ELECTRICAL SERVICES LAYOUT
TOWN HALL
LOWER GROUND FLOOR
HORNSEY TOWN HALL

Responses to L&P Comments 23.05.2022

LIGHTING AND FIRE ALARM LAYOUT
TOWN HALL
FIRST FLOOR

Project: **HORNSEY TOWN HALL**

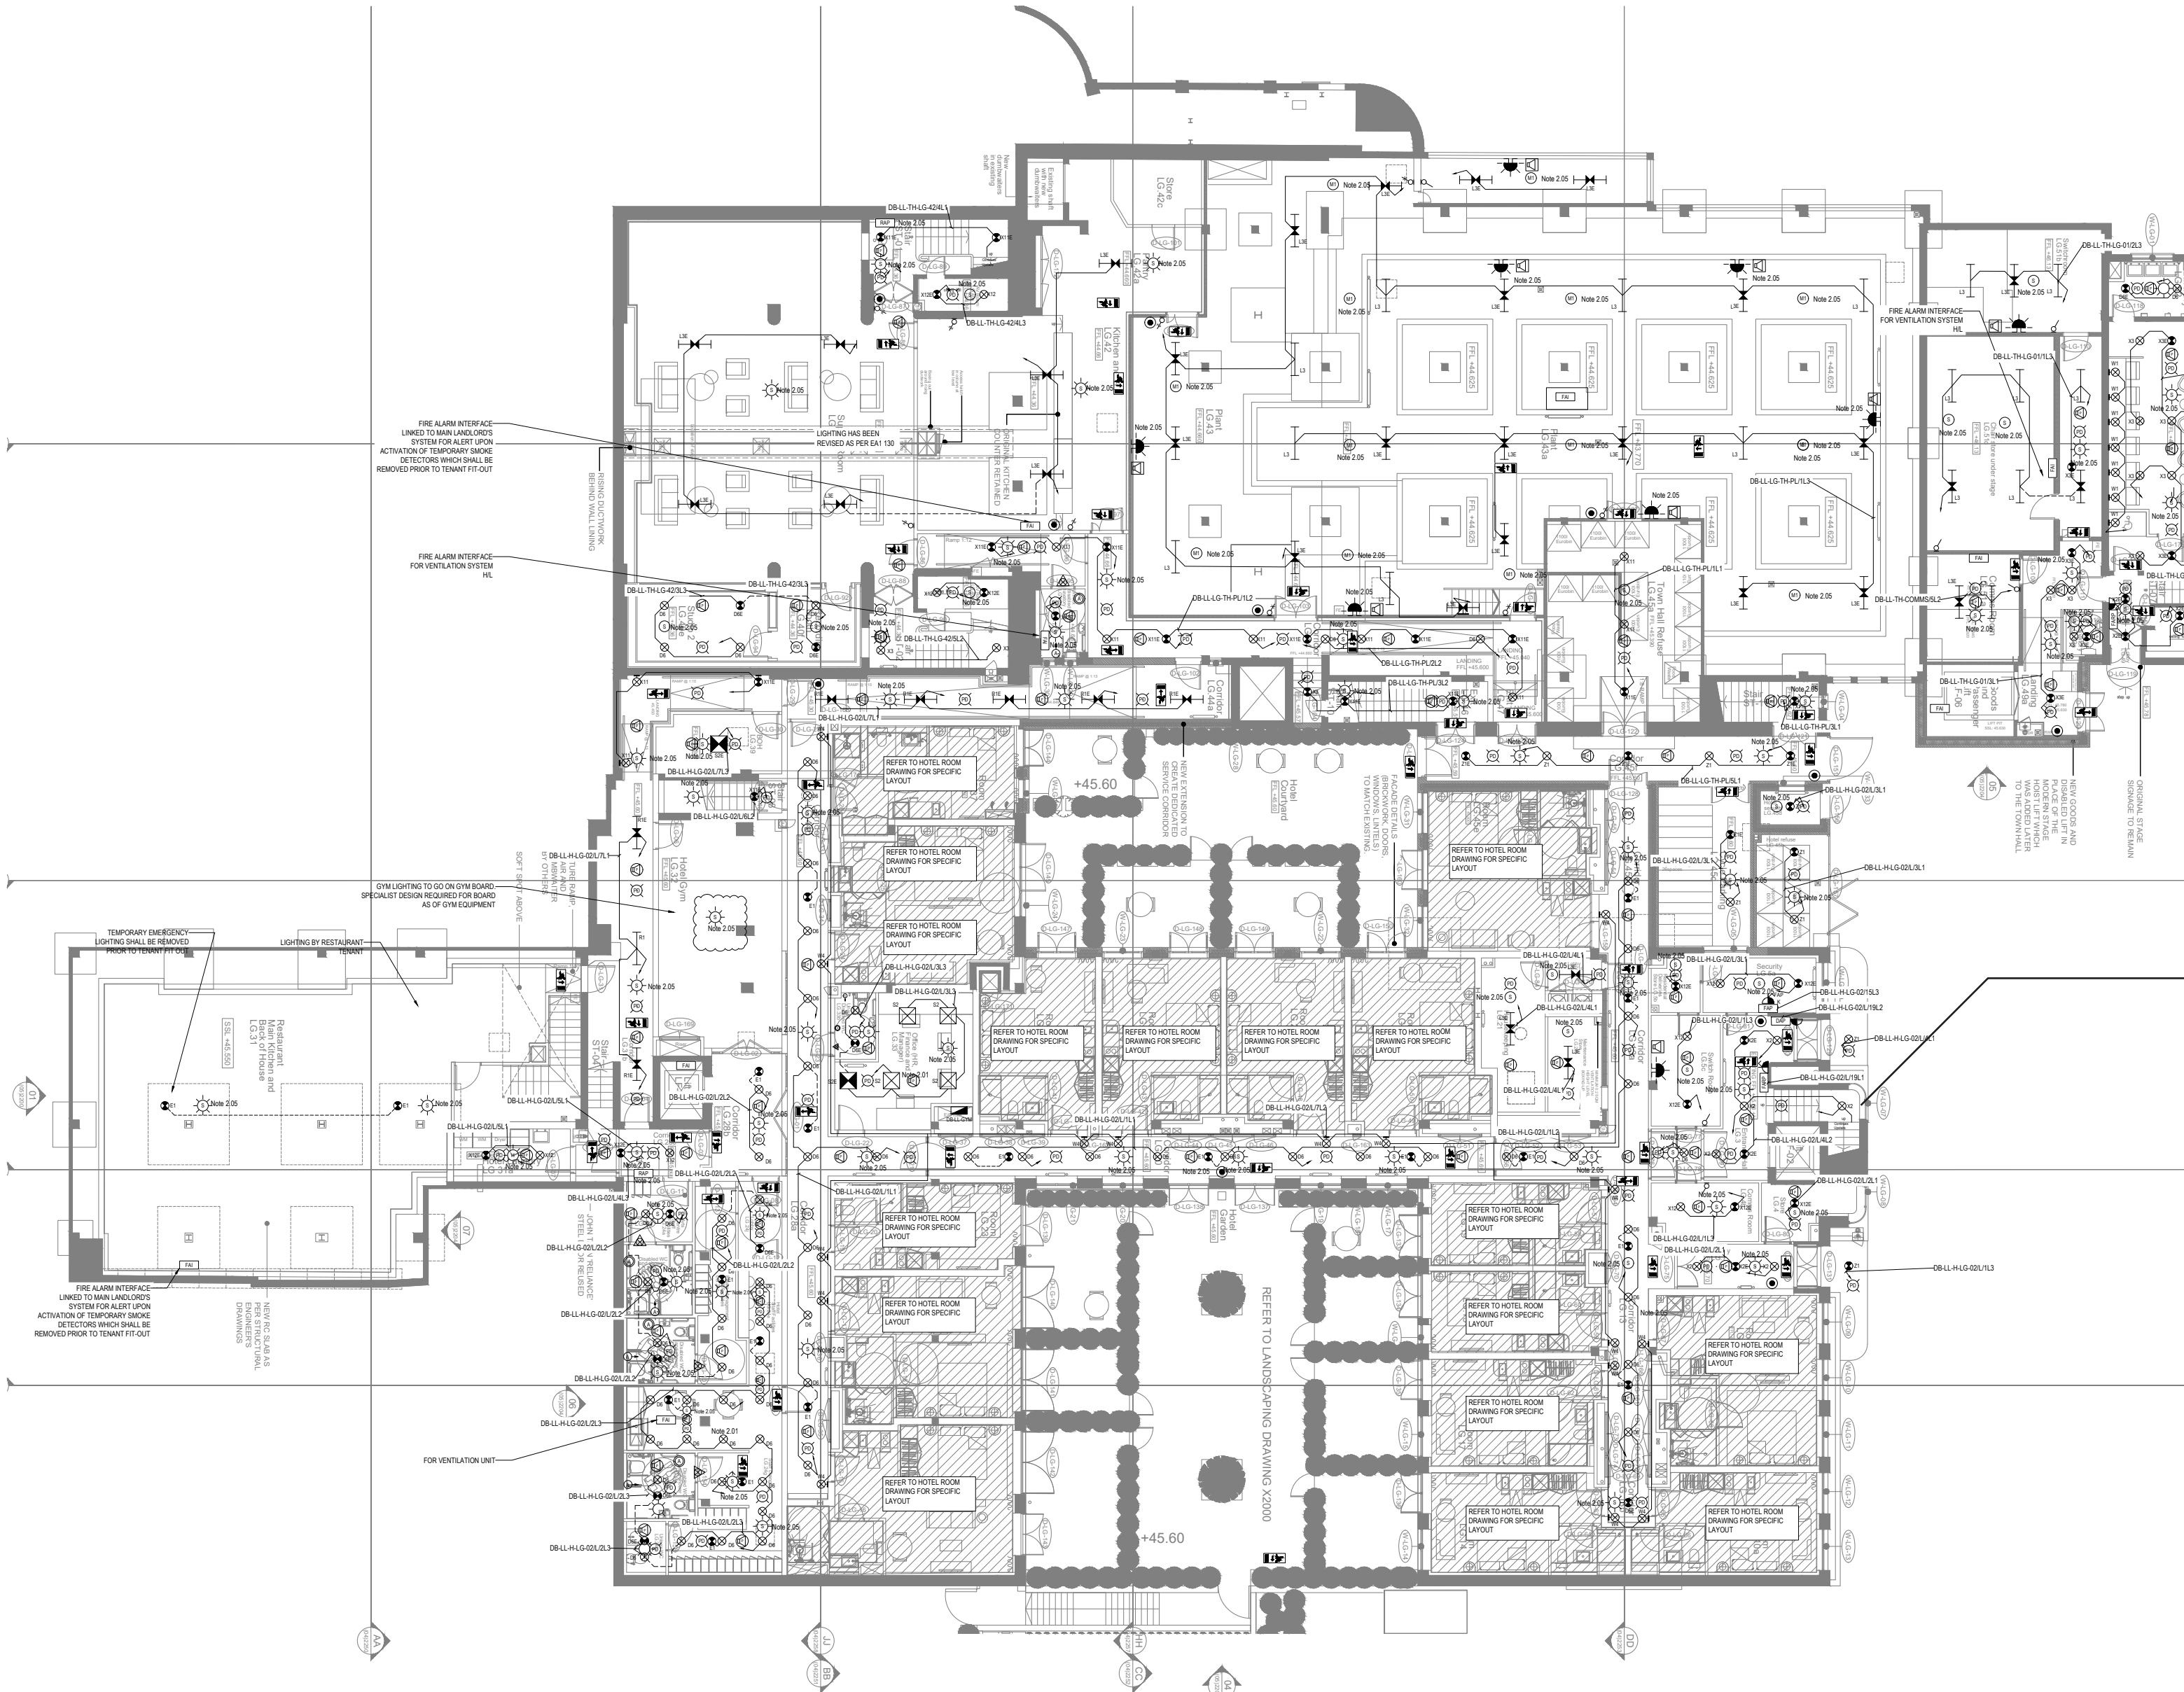
- Lamp does not incorporate the instruction for the Laundry room - Initial Architectural RCP and design intent required to capture this change
 - Luminaires T11 and L4 do not appear on Luminaire schedule - The Luminaire schedule has been resubmitted to reflect this change

- Please provide luminaire calculations - To be provided
 - Confirm DL light fitting can be accommodated within ceiling void - Yes
 - Supper room lighting layout does not appear to incorporate latest instruction - Initial Architectural RCP and design intent required to capture this change

- Please provide dimensioned setting out for each component - To be incorporated on architectural RCPs
 - Please include lighting control wiring diagrams - Please refer to manufacturer data sheets

- Show where exposed conduit is used to light switches - To be shown on on-build drawings aside from any areas that pose a significant visual concern
 - Confirm installation proposal where fitting to dry pot ceiling - Contractor to confirm

Refurbished lights time X2 - the stairs are a solid concrete construction, with light previously fed through cast in conduits. Site surveys have shown these existing conduits have collapsed over time and its not viable to reuse the existing cast in conduits or to chase in new ones. Face fixed metal conduits are to be installed and painted white to match ceiling finish.

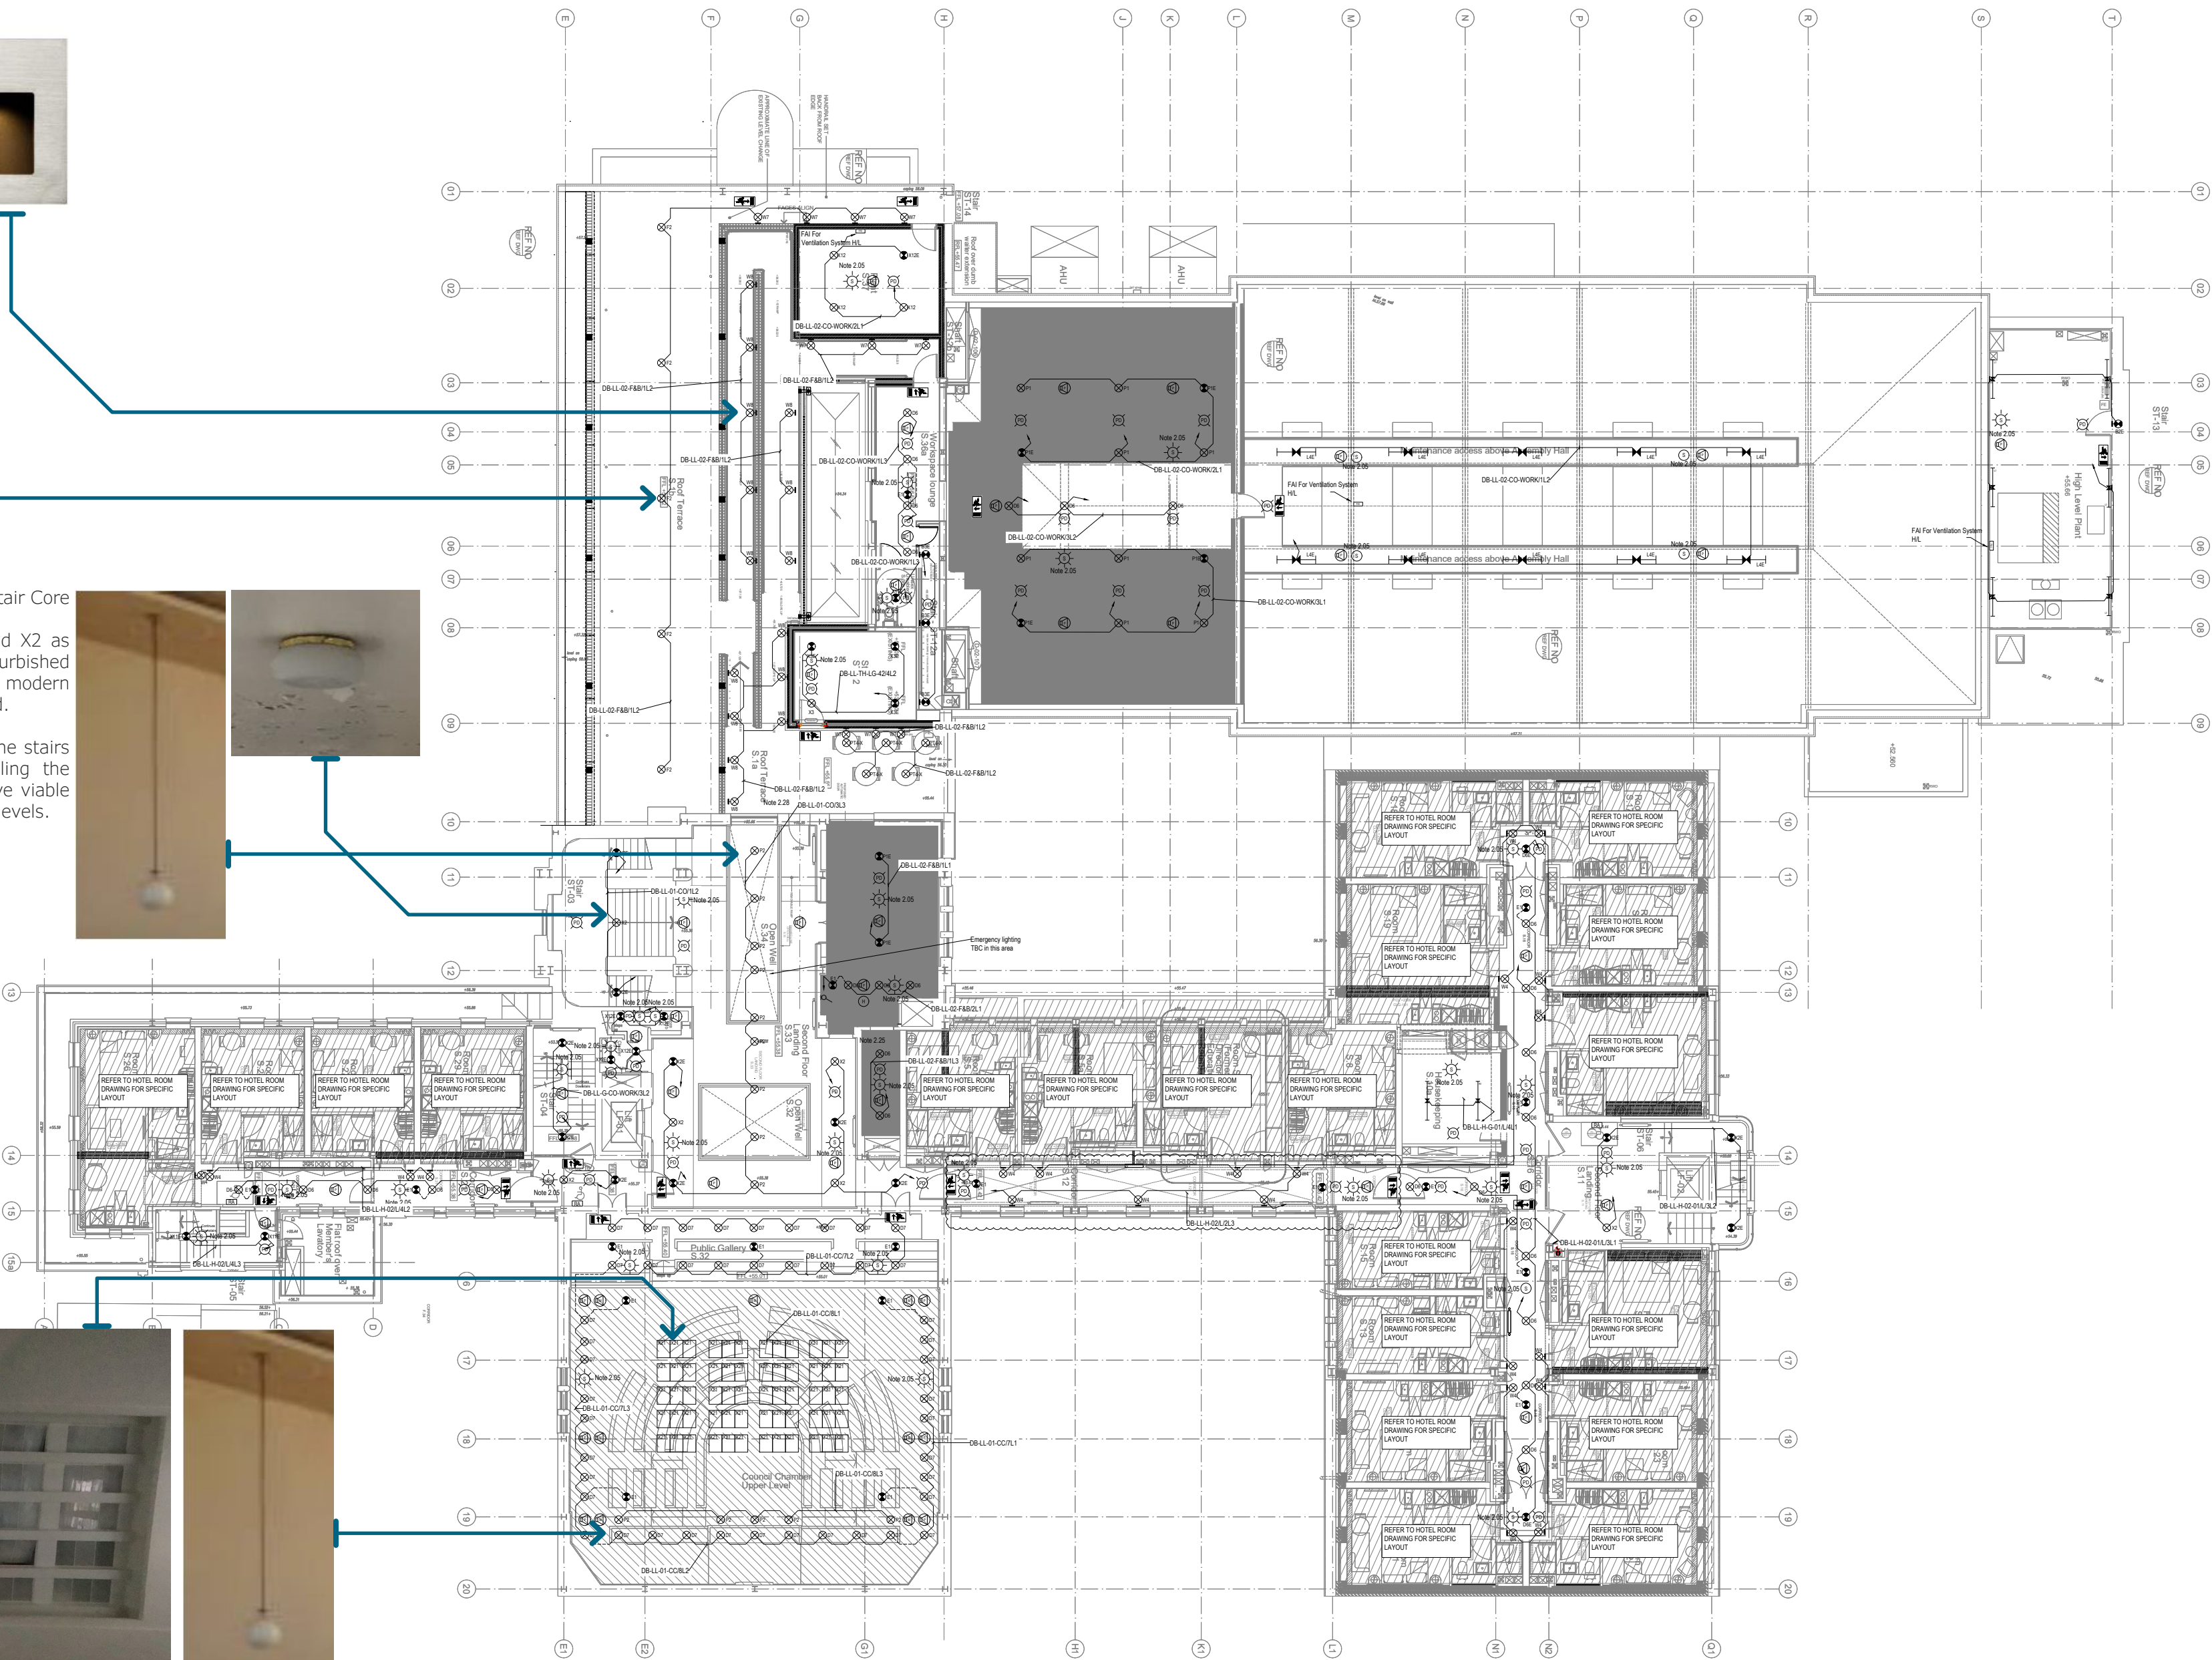
Luminaires X11 and L4 do not appear on Luminaire schedule. **= The luminaire schedule has been revised to reflect this change**

Please provide lux level calculations. **= To be provided**

Confirm DfE lighting can be accommodated within ceiling void. **= Yes**

Please provide dimensioned setting out for each component. **= To be incorporated on architectural RCPs**

Please include lighting control wiring diagrams. **= Please refer to manufacturer data sheets**

Show where exposed conduit is used to light switches. **= To be shown on as-built drawings areas from any areas that pose a significant visual concern**

Confirm installation proposal where fixing to cast ceiling. **= Contractor to confirm**
